Access Compliance Report

Public Rights-of-Way

(Curb Ramps)

Intersection ID: 10675	Main Street: HERRIN_AV	Cross Street: THE_PLAZA	Location: W
ADA ID: 50C643F5F660	Ramp Type: Perp	Initial Pass/Fail: Fail	Overall Compliance: No
Severity Score: 22.5			
Codes/Mitigation Info/Possible Solution		Field Measurements/Component Compliance

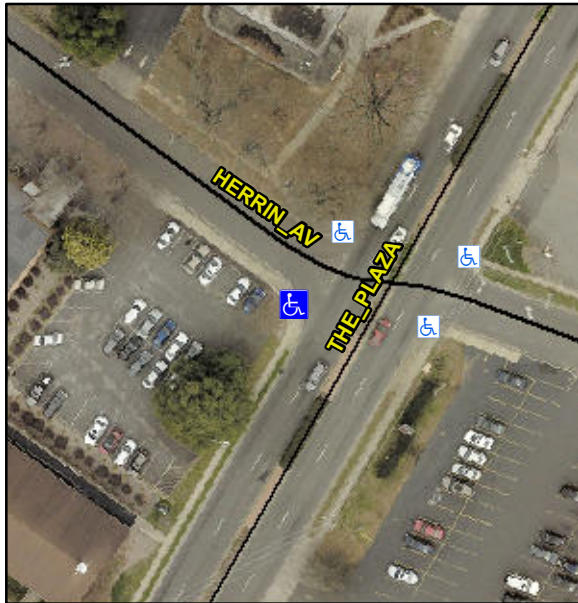
Not Found, R304.5.1, R304.2.2, R304.5.3

Compliance	Description	Data	Compliance	Description	Data
N/A	Ramp Length (in)	35.5	No	Ramp Slope (%)	8.8
No	Ramp Width (in)	45.0	No	Ramp XSlope (%)	4.0
N/A	Flare Type LT	N/A	N/A	Flare Type RT	N/A
N/A	Flare Slope LT (%)	N/A	N/A	Flare Slope RT (%)	N/A
N/A	Flare Traversable LT?	N/A	N/A	Flare Traversable RT?	N/A
N/A	Landing Length (in)	N/A	N/A	DWS Provided?	N/A
N/A	Landing Width (in)	N/A	N/A	DWS Contrast?	N/A
N/A	Landing Slope (%)	N/A	N/A	DWS Length (in)	N/A
N/A	Landing X Slope (%)	N/A	N/A	DWS Full Width?	N/A
N/A	Landing Curb? (Y/N)	N/A	N/A	DWS Offset (in)	N/A
N/A	Shared Landing?	N/A			
N/A	Gutter Ponding?	N/A	N/A	Gutter Slope (%)	N/A
N/A	Gutter Lip Ht (in)	N/A	N/A	Gutter X Slope (%)	N/A
N/A	Painted X Walk1?	No	N/A	Painted X Walk2?	N/A
	X Walk 1 Direction	To NE		X Walk 2 Direction	N/A
N/A	X Walk 1 Width (in)	N/A	N/A	X Walk 2 Width (in)	N/A
	X Walk 1 Slope (%)	0.9		X Walk 2 Slope (%)	N/A
	X Walk 1 X Slope (%)	4.3		X Walk 2 X Slope (%)	N/A

Remove & Replace Entire Ramp.
